Office Action Summary

10/682,050

Claims 1 – 2, 4, 9, 10, 14 are rejected under 35 USC Sec. 102(b) as anticipated by USP 5779890 to Bailey.

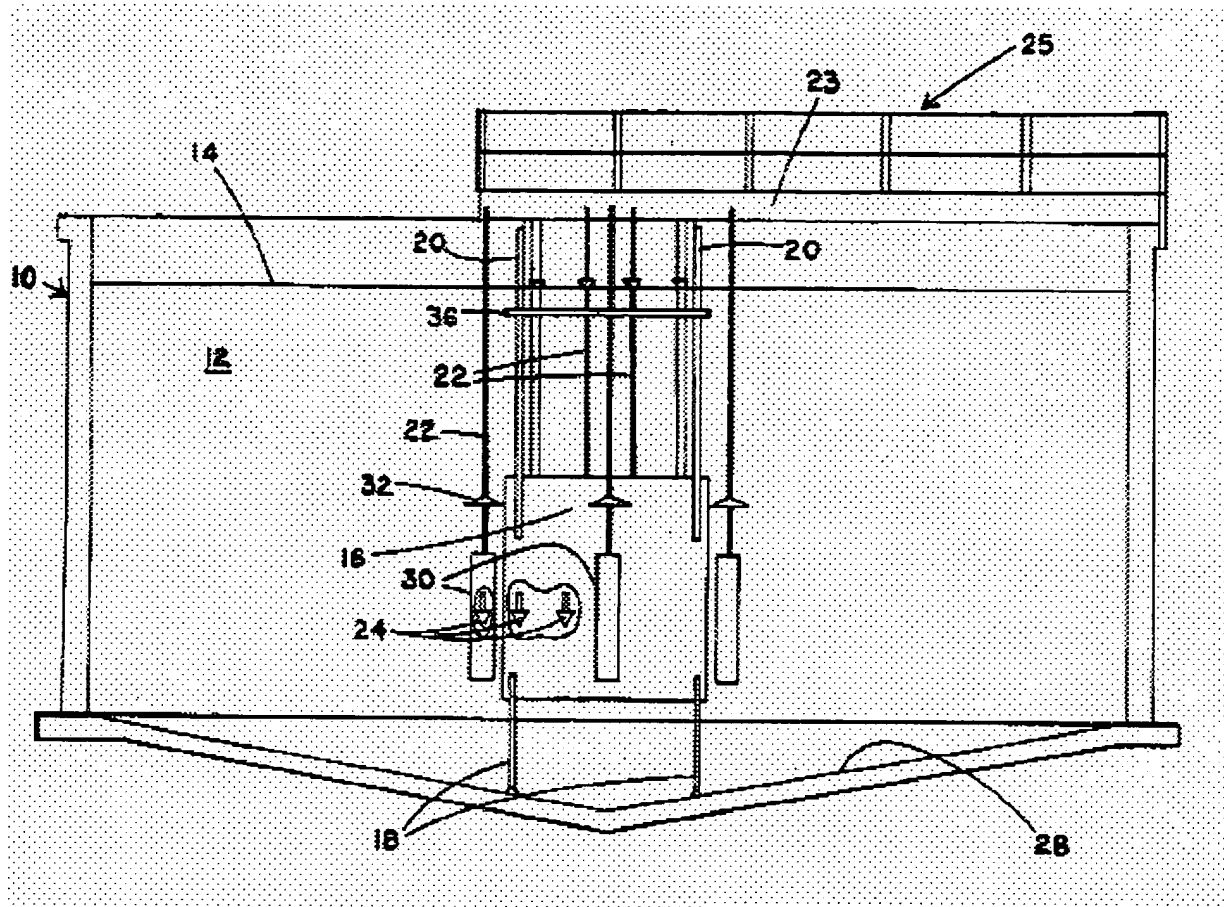
Fig. 1 of Bailey shows an anaerobic digester with a sloping bottom, a shell, a top section, and a middle section. The digester has a main central draft tube 16 and six peripheral draft tubes 30. The flow motivater, i.e., "means for pumping liquid," is methane gas (4/11). The upper and lower ends of the draft tubes are within the interior space of the shell.

The draft tubes may be symmetrical about the central axis, as in Fig. 1 or Fig. 11, but need not be, as in Fig. 7. Per claim 10, each draft tube is near the centerline. Per claim 14, see Fig 1A and Fig 1B flow lines.

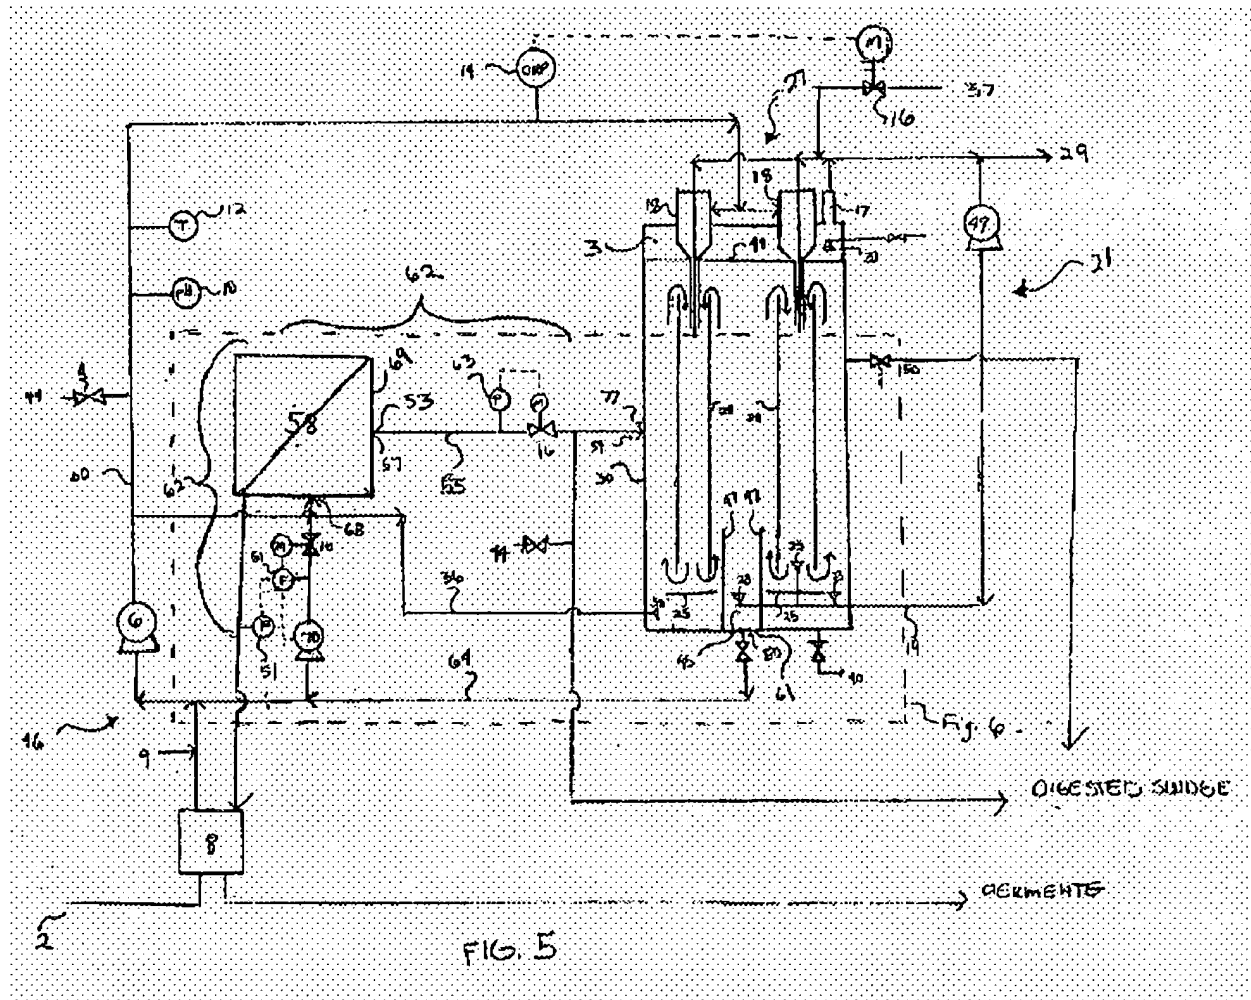
Fig 5 of US 20020192809 to Lanting describes a digester having two draft tubes 28, each of which has an inlet and outlet within the shell of the digester.

Note: At least one of the inlet and outlet of structures 18 and 47 is not "in" the shell.

Paragraph [0008] teaches away from modification of the flat-bottom digesters described in Lanting to one having a bottom with sloped sides.
